Docket Nos. 50-458/IE Bulletin No. 80-20
50-459/IE Bulletin No. 80-20

IE Bulletin No. 80-20
Date: July 31, 1980
Page 1 of 2

FAILURES OF WESTINGHOUSE TYPE W-2 SPRING RETURN TO NEUTRAL CONTROL SWITCHES

FIGURE 1

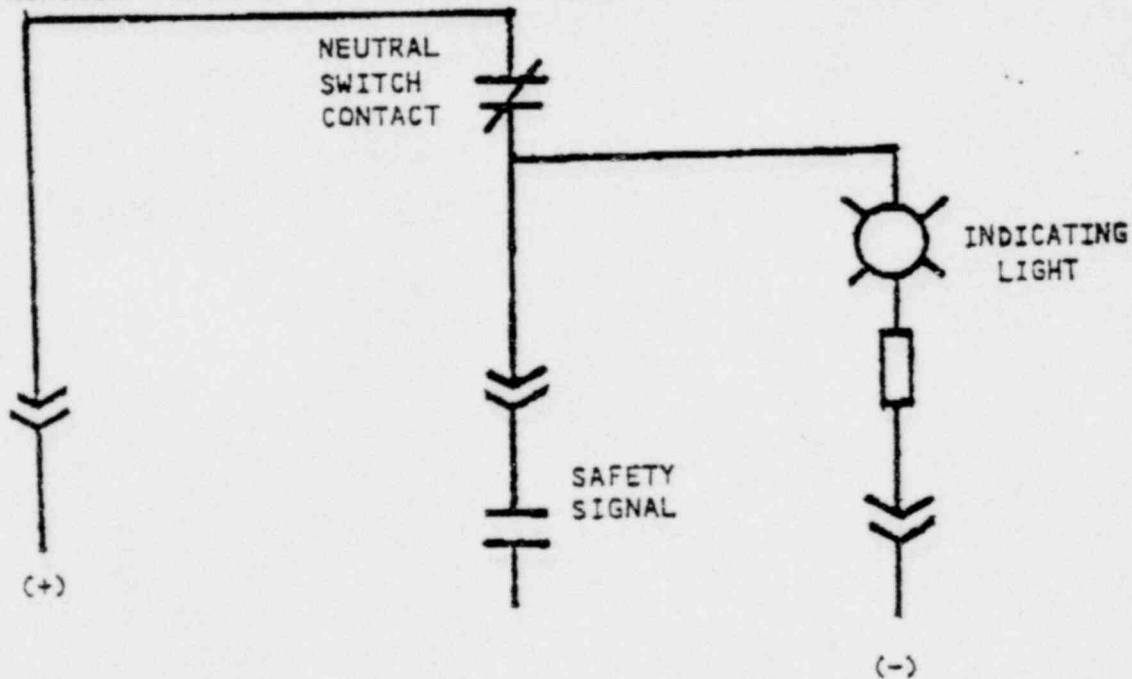
A review of this matter by Westinghouse led to the issuance of NSD Technical Bulletin No. NSD-TB-80-9 to the utility owners of all Westinghouse operating plants. The recommendations contained in the Westinghouse technical bulletin include: (i) testing the neutral position contacts of the subject W-2 switches for continuity, and (ii) rewiring of the indicating light circuit to permit the early detection of a neutral contact failure as shown in Figure 1.

Depending on how the indicating light circuit is wired, loss of continuity thru the neutral position contact of a W-2 switch could remain undetected until the equipment associated with the switch were called upon to operate. Since such a failure would be equivalent to by-passing the system associated with the switch, consideration should be given to rewiring the switches used in safety-related applications as shown in Figure 1. Such rewiring would provide an acceptable means for detecting contact failure, provided the indicating light is in the control room and readily visible by the operator. If the indicating light is not so located, consideration should be given to annunciating the neutral position contact failures at the control room to alert the operator of the inoperable status of a safety-related system. In addition, consideration should be given to adding redundant contacts to the W-2 switches or to replacing the W-2 switches with others having a more positive contact wiping action.

3. Licensees of operating plants and holders of construction permits shall describe the longer term corrective measures planned and the date by which such measures will be implemented by actual installation or by design change, as appropriate. As a minimum, the longer term corrective measures should include rewiring the indicating light as shown in Figure 1 provided the light is readily visible to the control room operator. If not, failures of the neutral position contacts should be annunciated in the control room.

PROPOSED REWIRING OF INDICATING LIGHT CIRCUIT (TYPICAL)
